KANSAS GAS AND ELECTRIC COMPANY

KMLNRC 85-063  
Re: Docket No. STN 50-482/OL  
Subj: Supplemental Information Regarding  
Chapter 17 of the Wolf Creek FSAR

ATTACHMENT A

Quality First Organization

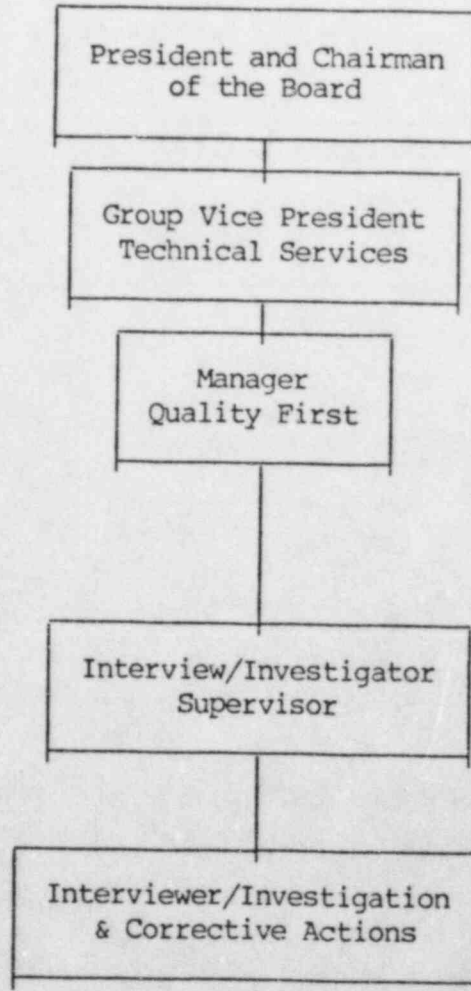
5. FSAR Section 17.2.1.11 introduces the Manager Quality First and the Quality First Program. This section of the FSAR states that the Quality First Program "provides an independent organization to investigate safety and quality concerns." Describe the program and the organization in more detail than given in 17.2.1.11.

The KG&E Quality First Program establishes the necessary administrative and investigative measures to ensure that all quality concerns related to safe plant operations, quality of work and compliance with project requirements are appropriately evaluated, investigated, dispositioned, verified and documented.

The overall objective of the KG&E Quality First Program is to:

- a. Assure that all WCGS employees, whether KG&E or onsite contractors, are made aware of the established channels/systems which they have available to state a quality concern.

- b. Ensure that quality concerns are evaluated and valid quality concerns are investigated, dispositioned, verified, and followed up in accordance with established procedural methods by an organization not directly responsible for the area of concern. Discrepancies are evaluated for reportability to the NRC per 10CFR50.55(e), Part 21, etc.

- c. Attempt to preserve the anonymity and/or prevent the harassment/discrimination of employees expressing quality concerns.
- d. Ensure that investigation results are made available to the individual(s) who initiated the quality concern provided they are known.

- e. Ensure all employees are made aware of and are provided an opportunity to discuss concerns with the investigative organization 1) prior to terminating employment at WCGS, or 2) anytime on a "walk-in" basis.

5. f. Establish a Quality Concern Investigation Status Report System to KG&E Management on an assigned frequency. Cognizant officials, managers, and regulators are kept apprised during the investigation.
